Agenda Item #5

Application 2024-24-CA

Summary of Request:

Demolish existing one-story frame single-family residence.

04 RIGHT ELEVATION (MIRRORED)
OPTION 2

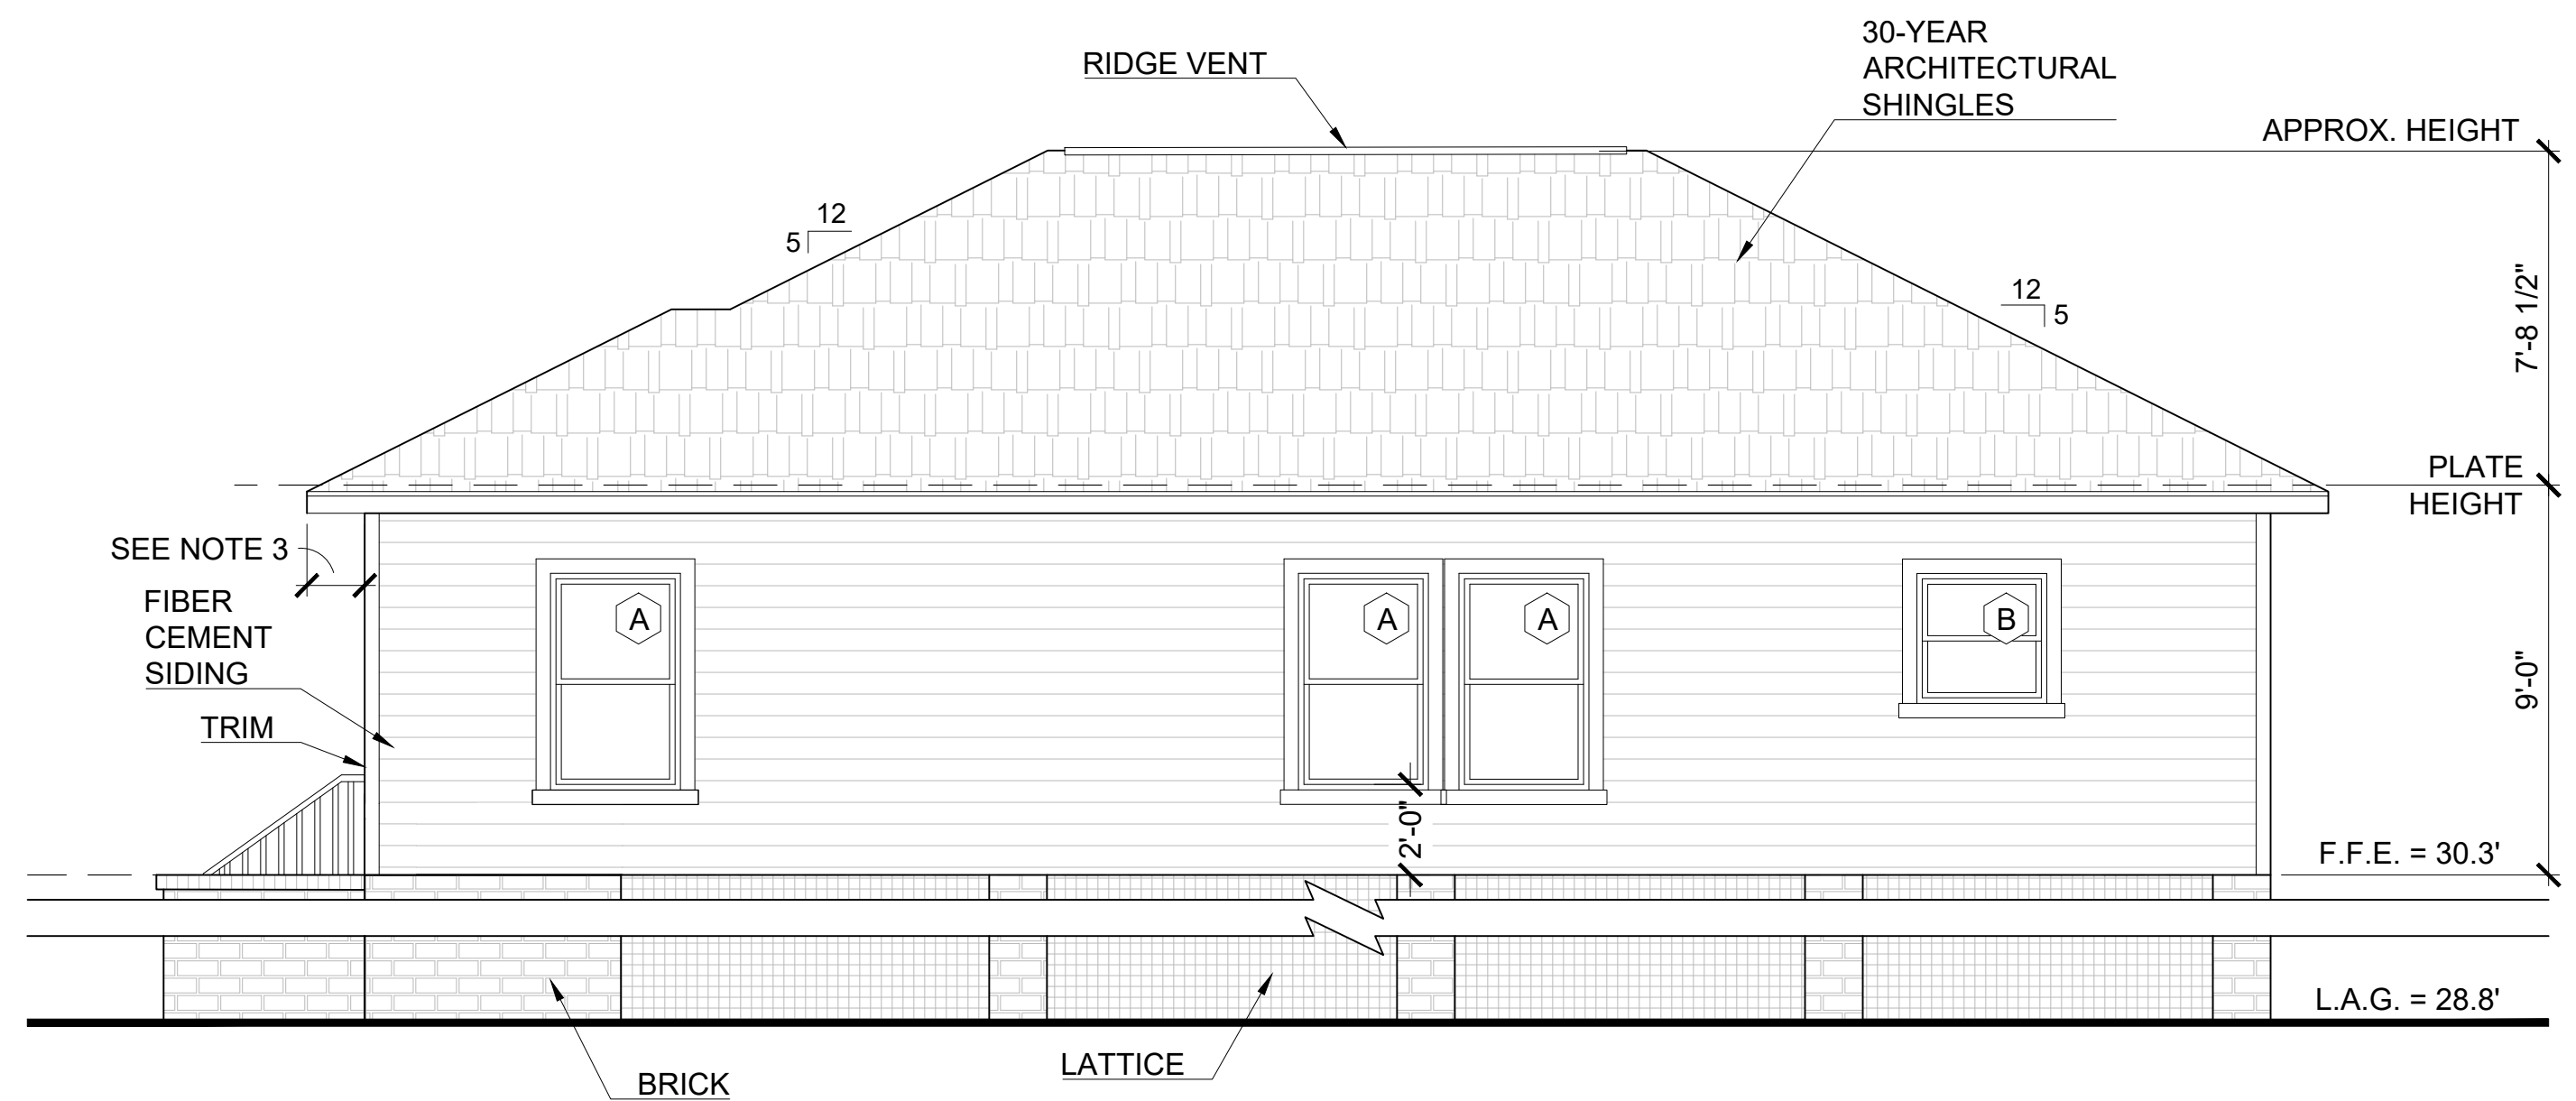
The historic structures in the immediate vicinity of the subject property vary slightly in size and details, but are fairly consistently one-story structures, rectangular in shape, some with off-set front or side projections. The proposed design for the subject lot is somewhat consistent in massing, proportions, and height with neighboring historic structures. It does lack offset side walls along the elevations expressed on many of the surrounding buildings which create a pattern of projections and recesses. The contributing buildings in its immediate vicinity sit on raised foundations which appear to be comparable in height to that proposed for the subject project. The intended use of masonry piers and lattice infill is likewise compatible with the historic neighborhood. (6.36,6.37, 6.43).

The street on which the subject property is located, along with immediate cross streets, are predominately populated with one-story gable or hipped roof bungalows of three or four bays, sitting on raised foundations and comprised of full or half-width front porches and restrained Craftsman style detailing such as exposed rafters, square columns, decorative brick detailing, and masonry knee walls. The majority of these residences possess long side elevations, many with occasional projections and recesses, and varying fenestration patterns. Proposed features of the three-bay, one-story bungalow-like design such as the hipped roof, front porch, projecting front bay, and foundation design would uphold conventions of the district, and assimilate the proposed new construction with neighboring historic buildings, as the *Guidelines* advise. The proposed materials of fiber cement siding, wood, and shingles are acceptable building materials within Mobile's historic districts, which respect the traditional building materials observable on nearby historic structures and throughout the historic district. The applicant has stated that the front and rear paneled entry doors would be of steel construction. Vinyl clad wood, proposed for the windows, is an approved material for new construction under the *Guidelines*. A three-over-one light configuration would be more appropriate than the proposed one-over-one pattern. The solid-to-void ratios along the side and rear elevations are not entirely compatible with those of nearby historic structures. Expanses of blank walls such as those seen on the south and west elevations in the submitted plans are not present on historic bungalows in the neighborhood. (6.38 - 6.42, 6.44, 6.45).
